# HISTORIC AND DESIGN REVIEW COMMISSION

August 04, 2021

**HDRC CASE NO:** 2021-350  
**ADDRESS:** 407 E EVERGREEN  
**LEGAL DESCRIPTION:** NCB 396 BLK 29 LOT 8  
**ZONING:** MF-33,H  
**CITY COUNCIL DIST.:** 1  
**DISTRICT:** Tobin Hill Historic District  
**APPLICANT:** MARK SALVADOR/FISHER HECK ARCHITECTS  
**OWNER:** ROSEN RANDALL A & CYNTHIA E  
**TYPE OF WORK:** Construction of two, 1-story rear accessory structures, exterior modifications  
**APPLICATION RECEIVED:** July 12, 2021  
**60-DAY REVIEW:** Not applicable due to City Council Emergency Orders  
**CASE MANAGER:** Stephanie Phillips  
**REQUEST:**

## 1 SITE PLAN

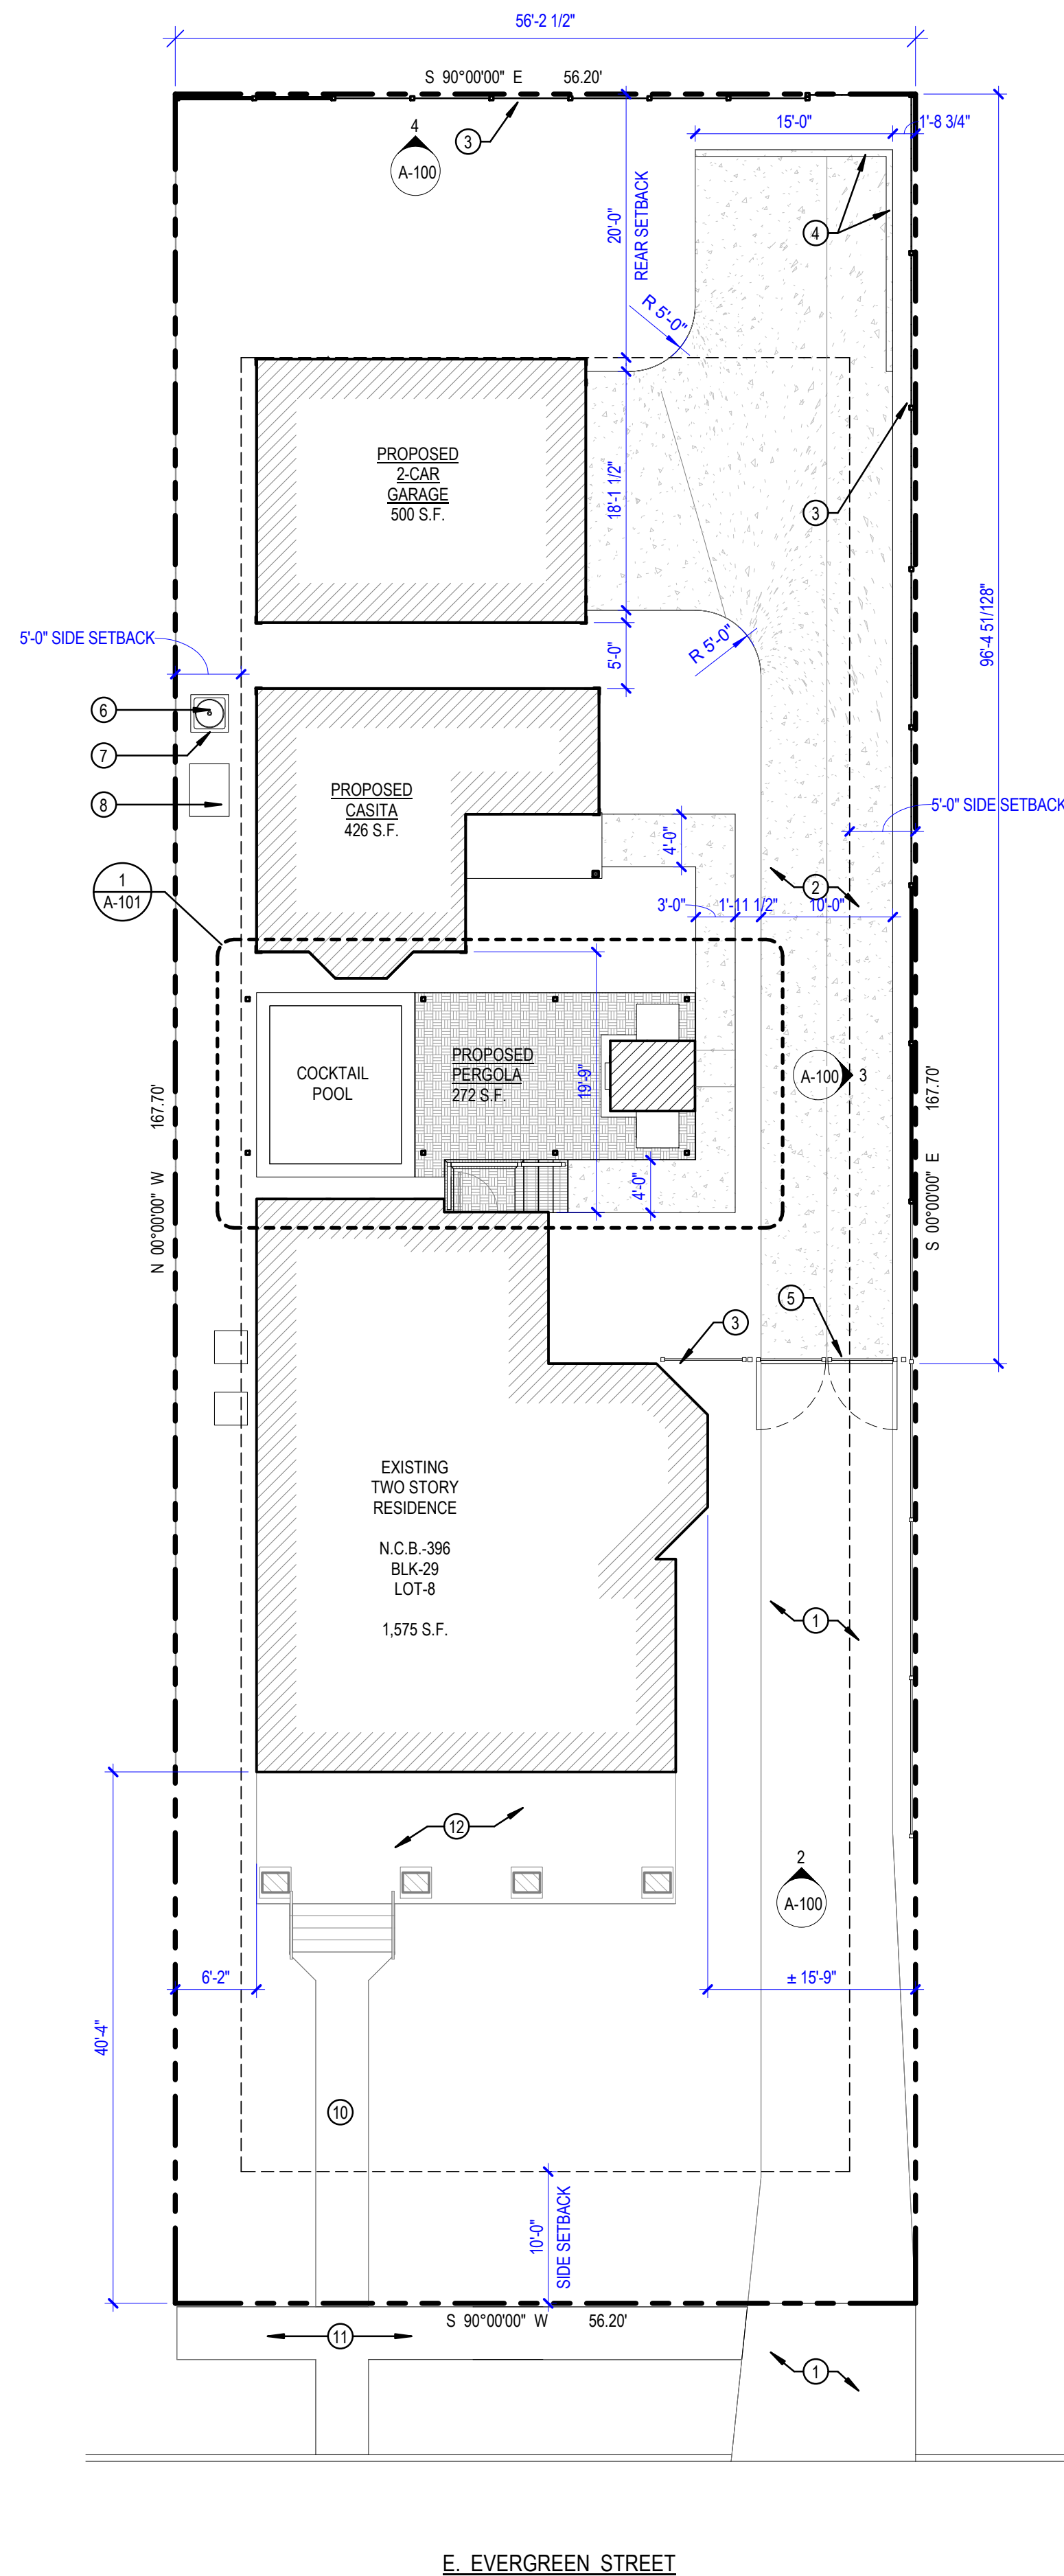
- c. FOOTPRINT AND LOT COVERAGE – The applicant has proposed to construct two new rear accessory structures. Both structures will be 1-story in height. One structure has a footprint of approximately 430 square feet and the second, a 2-car detached garage, has a footprint of approximately 500 square feet. The existing primary structure has a footprint of 1,575 square feet. Per the applicant, the overall lot coverage of the structures, including the existing primary structure, will total 57%. According to the Guidelines, the addition of new structures should follow the historic development pattern in terms of footprint and total lot coverage should not exceed 50%. However, this block of E Evergreen and the surrounding blocks within the district are characterized by properties that exceed 50% lot coverage. This lot is deep and narrow, and the structures are also both located behind the primary structure, follow

- d. **REAR STRUCTURES: SETBACKS AND ORIENTATION** – The applicant has proposed to construct two new 1-story accessory structures to the rear of the primary structure. According to the Guidelines, setbacks for rear structures should follow the predominant development pattern of the historic district. The new construction aligns with the western façade's setback and follows the historic development pattern of the district, which features larger primary structures and subordinate rear accessory structures. Staff finds the request appropriate. The applicant is responsible for complying with zoning requirements and obtaining a variance from the Board of Adjustment if applicable.

- iv. That the applicant complies with all setback requirements as required by Zoning and obtains a variance from the Board of Adjustment if applicable.

1 CASITA ROOF PLAN  
1/4" = 1'-0"

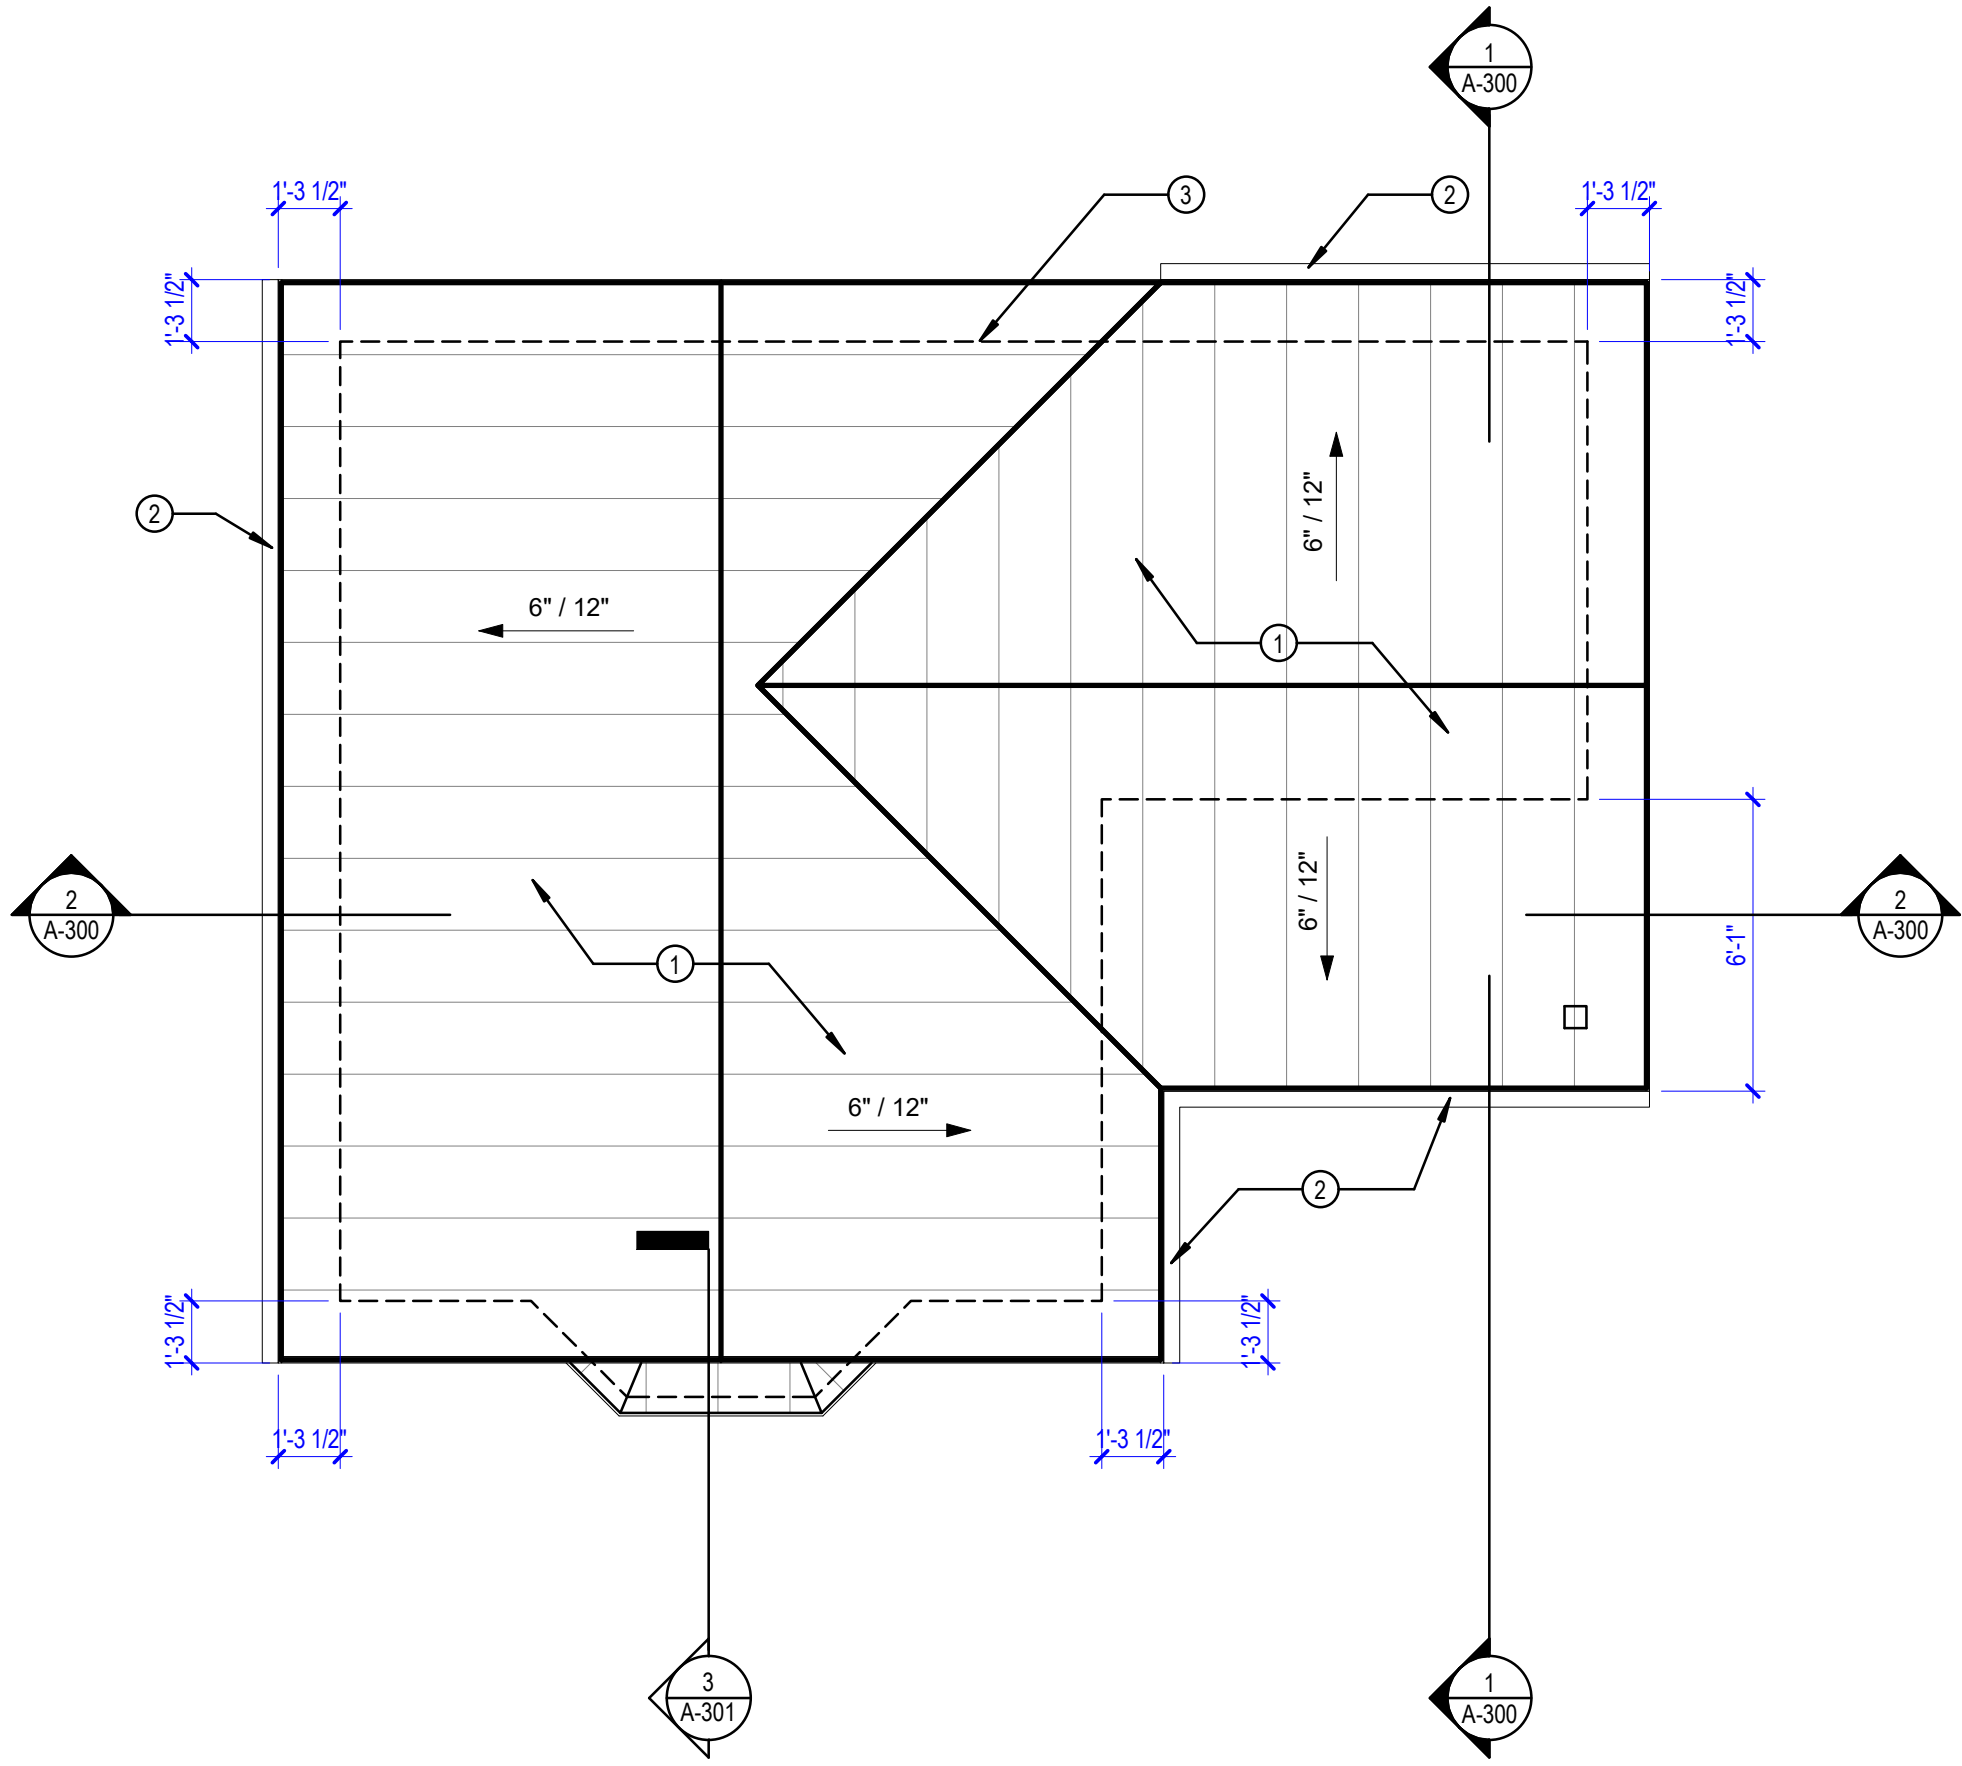
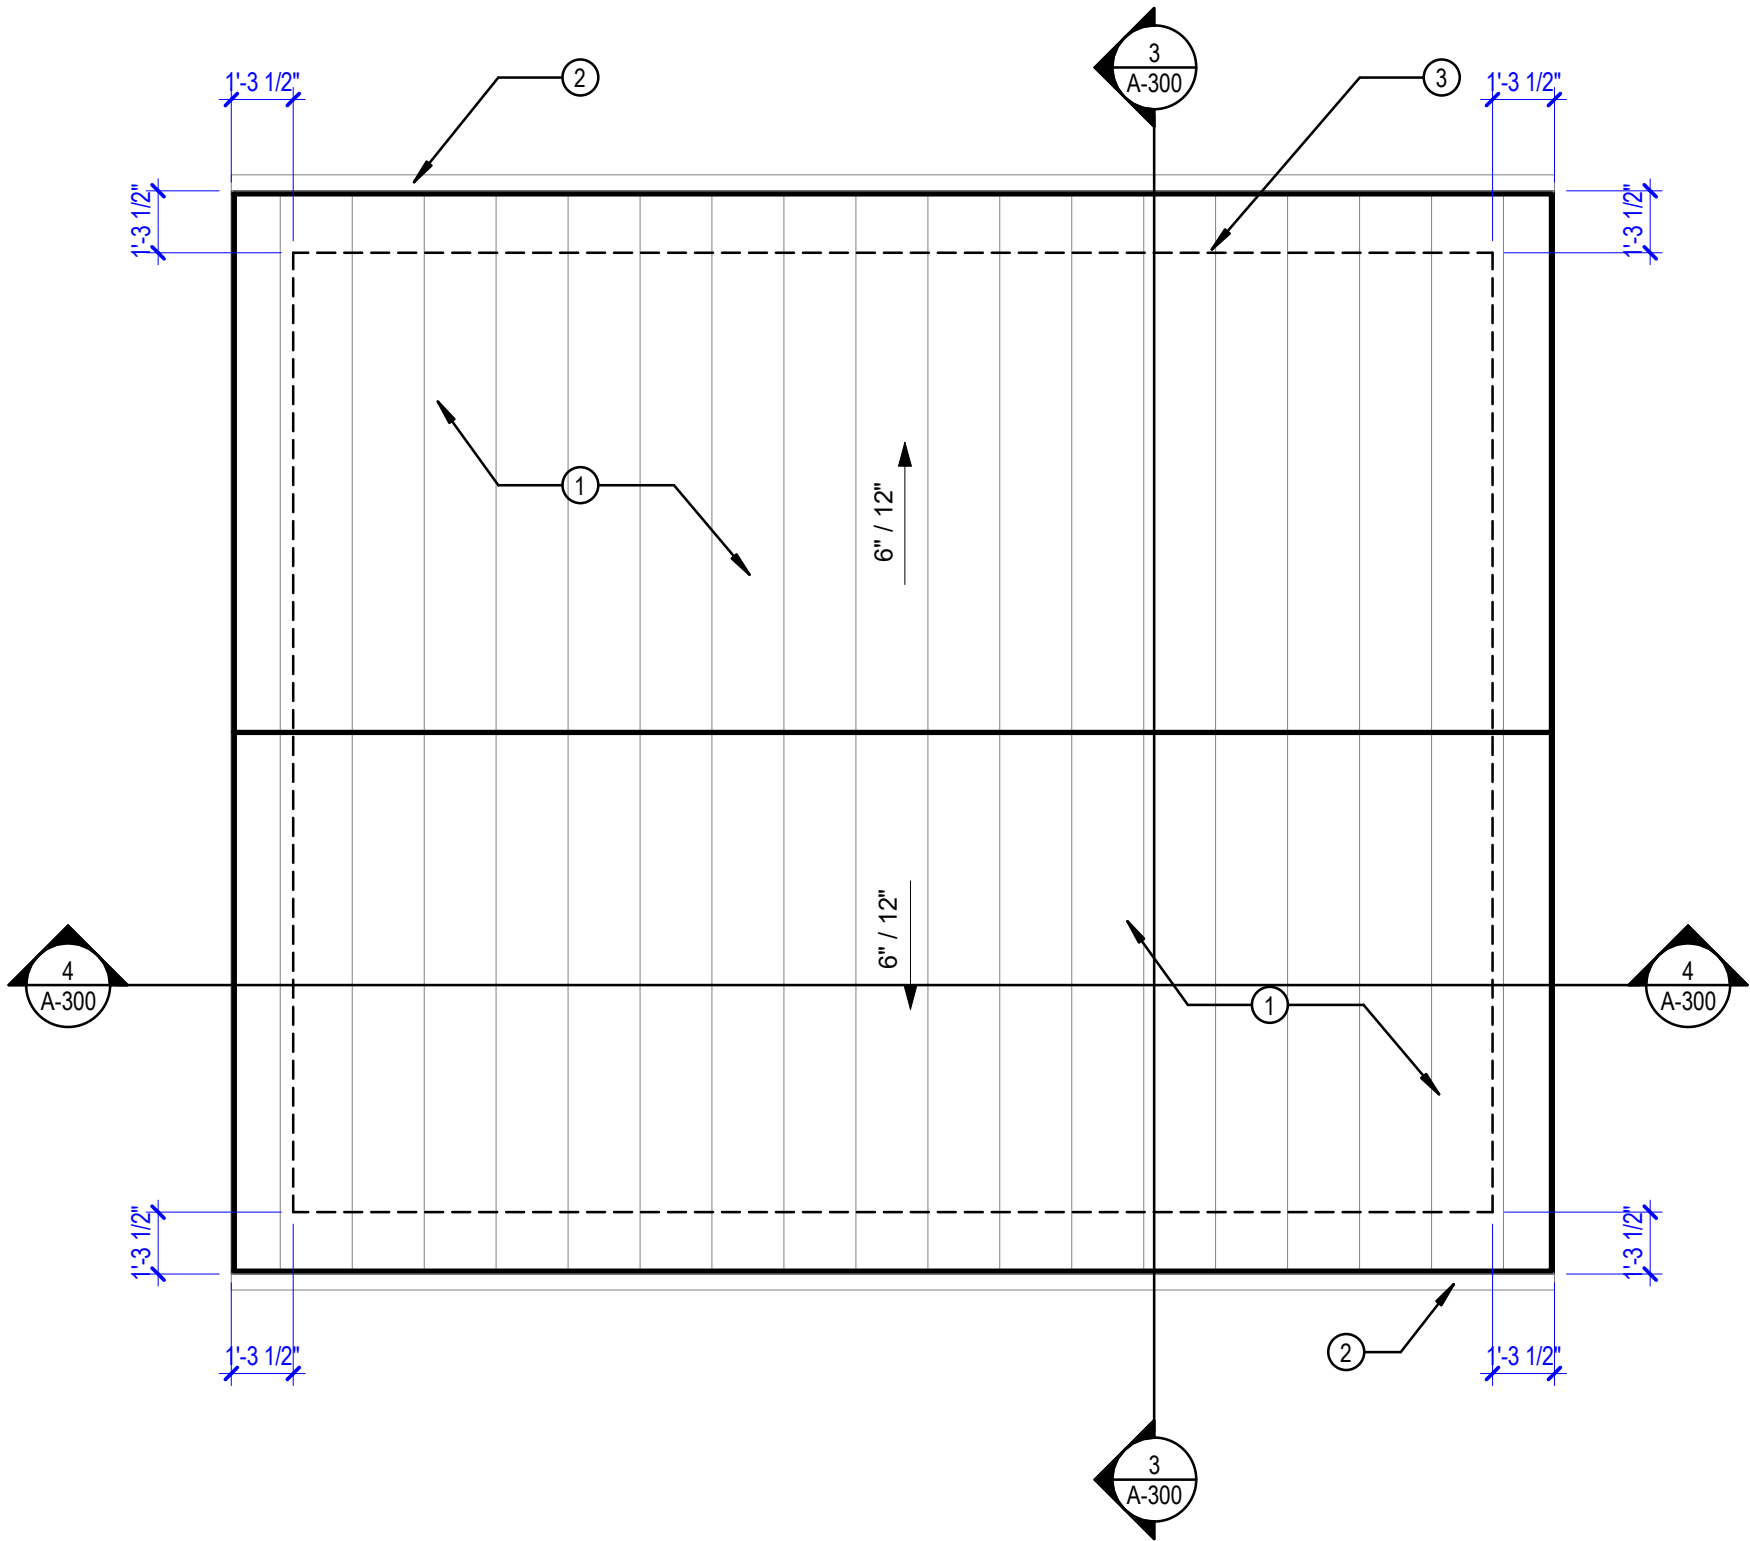
- f. **ROOF FORM** – The proposed rear accessory structures will utilize a gable and cross-gable roof forms with a 1-story height that is over a fully story subordinate to the primary structure. The roofs feature traditionally extending eaves and will be standing seam metal. Staff finds the roof forms to be generally appropriate.

- iii. That the applicant installs a standing seam metal roof featuring panels that are 18 to 21 inches wide, seams that are 1 to 2 inches high, a crimped ridge seam, and a standard galvalume finish. Panels should be smooth without striation or corrugation. Ridges are to feature a double-munch or crimped ridge configuration; no vented ridge caps or end caps are allowed. An on-site inspection must be scheduled with OHP staff prior to the start of work to verify that the roofing material matches the approved specifications. All chimney, flue, and related existing roof details must be preserved.
